City of Canby

MINOR PARTITION STAFF REPORT

FILE #: MLP 14-03

LOCATION: 672 S Fir Street

Proposed Partition, Ed Netter, Applicant	
672 S Fir Street, Canby, Oregon	
Discard Prior Copies	
DATE: 11/12/2014	SCALE: 1" = 60'
DRAWN BY: A. Manuel

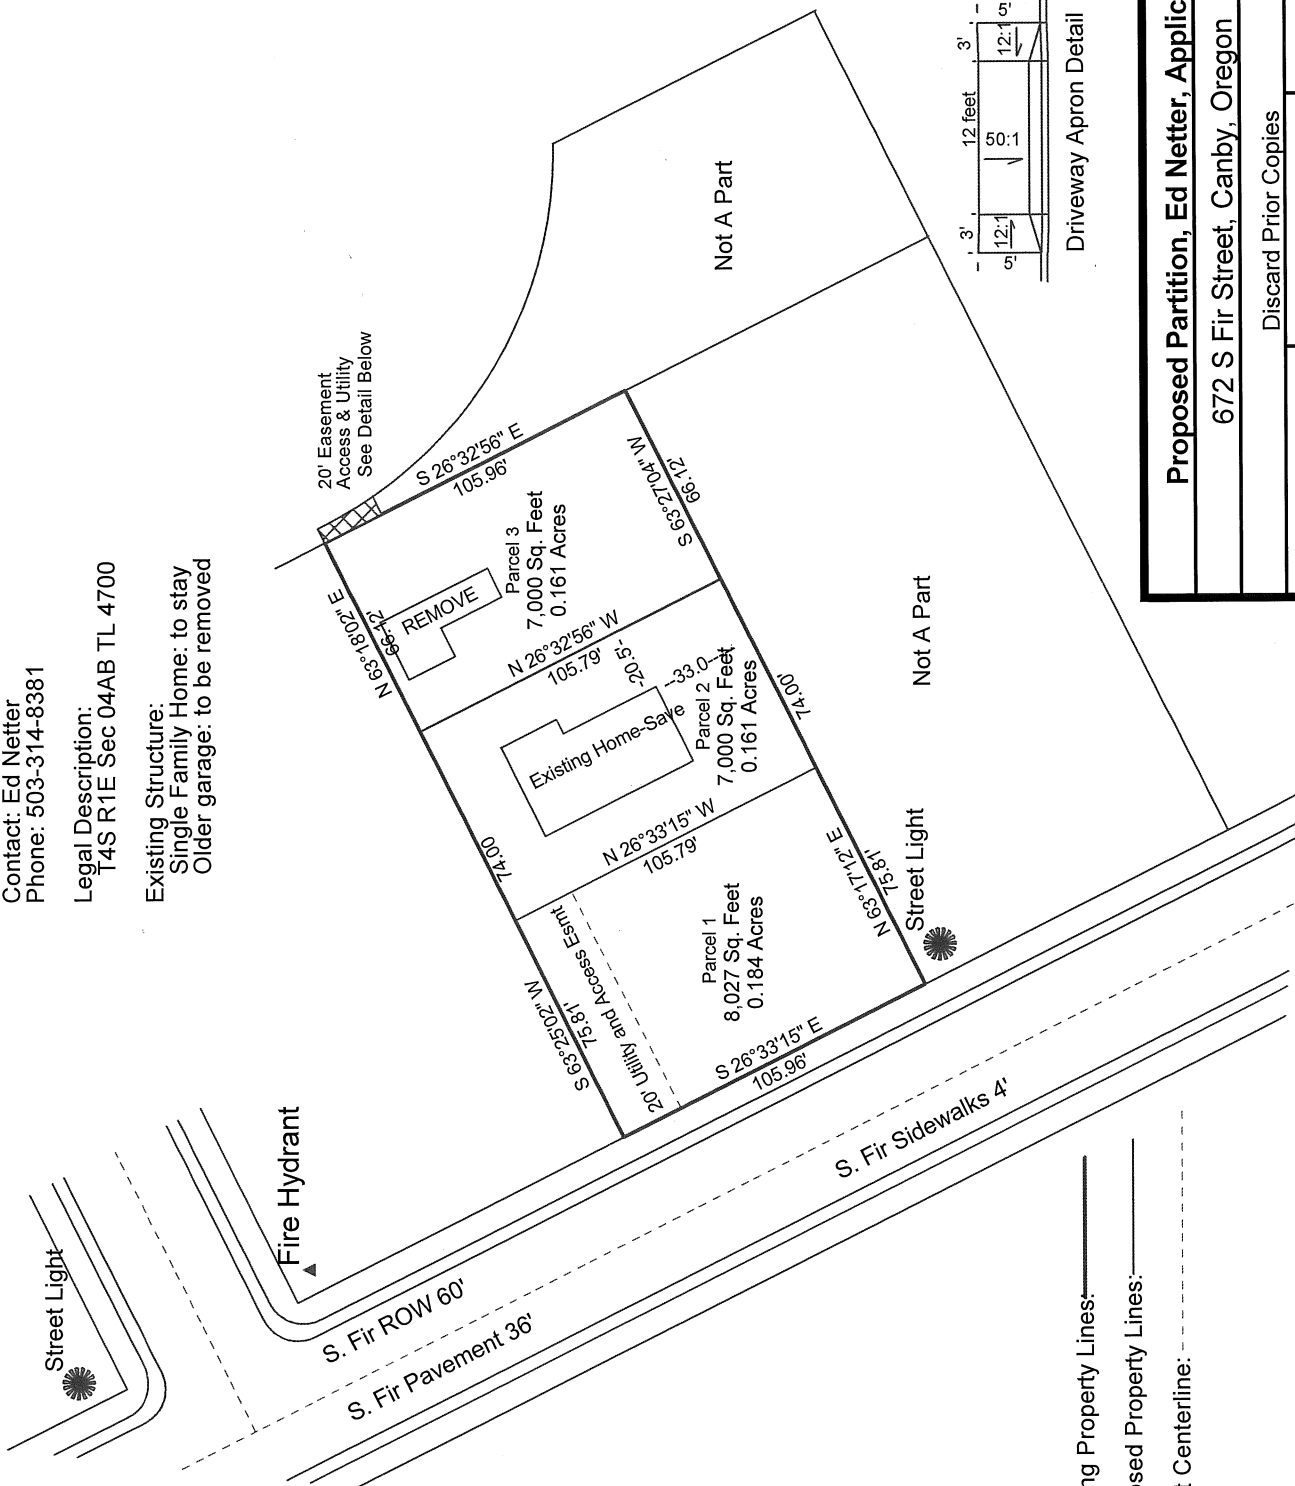
A. *Modified Non-Typical Means of Access for Flag Lot.* Parcel 2 of the proposed partition will be provided access in a mostly typical manner for a flag lot arrangement by way of an access easement across Parcel 1 to the parcel behind. More often an actual parcel ownership arm is provided to provide direct public street access to more directly meet the minimum public street frontage requirement. A usual lot is required 60' of frontage on a public street, however the Planning Commission may allow flag lots, and cul-de-sacs where access and building sites are determined to be adequate. Parcel 3 is proposed to take access across a short access easement to an adjacent property to the northeast which is not a part of the proposed Minor Partition. This access solution is unique to this particular proposed lot arrangement, and is considered to be a viable and arguably preferred means of access as it lessens the total length of private cross access easement needed. In this case, providing access to Parcel 3 in the opposite direction to SE 6th Place eliminates a code compliance issue pointed out by staff if the access easement from Fir Street was utilized to serve Parcel 3 as its 20' width would not accommodate the 5' minimum setback requirement from the existing home to be retained and remodeled on Parcel 2. The applicant has indicated that he has secured agreement from the adjacent property owner to establish the proposed 20' wide access and utility easement. This must become a condition of approval to have this easement recorded prior to filing of record the partition plat.

B. *Retain existing 4' Wide Sidewalk Rather Than Widen to Current 6' Standard.* The proposed partition can be considered an infill opportunity where the residential density is increased in an already developed residential neighborhood. An existing 4' wide sidewalk built to the curb runs the full length of this partition along the S Fir Street frontage and the block as a whole. The current TSP adopted public right-of-way cross section standard for a standard local street is for a 6' wide sidewalk constructed anywhere from 0 to 8 feet behind the curb to provide a street tree planter strip depending on the available right-of-way. With a total existing street right-of-way of 60' there would be enough right-of-way to provide a 5' wide planter strip next to the curb and a 6' wide new sidewalk. This however would likely be deemed to be out of place and character with the existing developed neighborhood and would require tapers along the partition lot frontage to match the existing 4' wide curb tight sidewalk arrangement existing within the remainder of the block. Therefore, staff would recommend that an exception to the planter strip and 6' foot sidewalk would be appropriate in order to continue continuity within the remaining developed block, especially since the existing sidewalk

D. Utility Services to Existing Home. The applicant did not provide information as to the location of existing service utilities to the existing home to be retained on Parcel 2. The applicant is responsible to work directly with each desired utility service provider to either relocate existing services within the proposed 20' wide access and utility easement through Parcel 1 or to provide a private easement across Parcel 1 protecting and assuring continued use of any existing private service lines. NW Natural has indicated that the existing gas line serving the residence at 672 S Fir Street will likely need to be relocated as it currently crosses Parcel 1 in the buildable footprint area. Staff does not know the location of electric and telephone services. We do need to assure that all necessary utilities have a means of protected access to service each proposed lot. The 2 proposed access and utility easements should provide a location for these private service connections.

Findings: An existing drive will be placed in a common access easement to provide access to Parcel 1 & 2. This drive complies with 30' separation from a street intersection and the desired 10' separation from an adjacent drive. The proposed new access easement and drive out to SE 6th Place to serve Parcel 3 will exceed the minimum 30' separation standard from a street intersection and 10' separation from existing drives on SE 6th Place.

Findings: Two of the proposed lots exceed the 7,000 minimum lot size while the third is just 6 square feet short. The Planning Commission may approve lot area exceptions when the average of the partition lot size shall not be less than 7,000 square feet. The average of the 3 proposed lots is 7342 sf. There does not appear to be any particular reason why each lot is not proposed to meet the minimum standard but use of the lot averaging exception would be suitable. Staff is concerned that Parcel 1 should be larger, as a front yard setback requirements of 20' from Fir Street and the rear yard setback of 15' for a single story home and 20' for a two story home will only leave 33' and 28' respectfully for a home footprint depth. The minimum lot width of 60 foot is met. The building height and maximum impervious area will be verified during the building permit process. Staff recommends that the lot depth of Parcel 1 be increased by 2 feet to better account for the setbacks that will apply when siting a home on that lot.

2. Canby Utility will need a 10' easement on the N side of parcel2 and Parcel 3, to provide electrical service to the property

1. The existing 4.5 feet wide sidewalk is in good condition and no changes are needed. However, the developer will be required to provide a minimum of 36" wide clear path between the back of the existing mail boxes to accommodate ADA requirements.
2. All the intrusive branches from the existing hedge at the back of the existing sidewalk must be trimmed.
3. The submitted plan doesn't show how the existing driveway and the new driveway within the new 20-foot utility easement will be impacted.
4. The developer shall provide a sewer and water plan for serving the new parcels and identify any impact on the existing utilities serving the existing residence.
5. All trench repairs and work in the public right of ways shall comply with the City current Public Works Standards.
6. We have no concerns with the proposed access to parcel 3.

- 1) Request for the gas service to be cut and capped.
- 2) Request for new gas service for Parcel 1 and Parcel 3 and relocation of gas service to parcel 2 existing house. (there may be a charge to relocate service for Parcel 2).
- 3) Provide a 10-foot wide gas utility easement across Parcel 1 for the benefit of Parcel 2. This may be problematic as the gas service crosses the building footprint for Parcel 1.

We have lived at the corner of 6th Avenue and 6th Place for 34 years. Our back yard borders 672 S. Fir Street. We have anticipated the proposal of dividing this property into flag lots for years. Our only concern relates to the cedar trees which border Mr. Netter's property, our property and our neighbors. These trees provide shade and greatly enhance the landscaping of our back yards. We would not oppose this land partition unless these trees were being considered for removal, or if they were to be damaged in the process of construction. Since these trees are along the boundary line and there is a driveway already established, we do not see any need for them to be disturbed. Thank you.

- d.** Submitted citizen and agency comments/written testimony
- 2.** A sewer and water service plan for the new parcels and impact on service to the existing house shall be submitted and approved by City prior to filing the partition plat of record.

- 4.** A cross access and maintenance agreement shall be filed of record for each proposed access easement.
- 5.** The applicant shall submit a Tree Protection Plan to indicate which trees can be preserved along the northern boundary of the existing Tax Lot if agreed upon at the public hearing.

- 6.** The applicant/developer shall be required to provide a minimum 36" wide clear path behind the mailboxes to accommodate ADA requirements, and trim all intrusive tree branches and hedge overhang from the existing sidewalk prior to filing the partition plat.

- 8.** The offsite access and utility easement to serve Parcel 3 shall be recorded prior to filing the partition plat associated with MLP 14-03.
- 9.** The applicant is responsible to either relocate all necessary utility services within the proposed 20' wide access and utility easements to serve Parcel 2 & 3 or provide a private easement across Parcel 1 protecting and assuring continued use of those private service lines where they exist if not in conflict with the proposed footprint of the new home on Parcel 1.
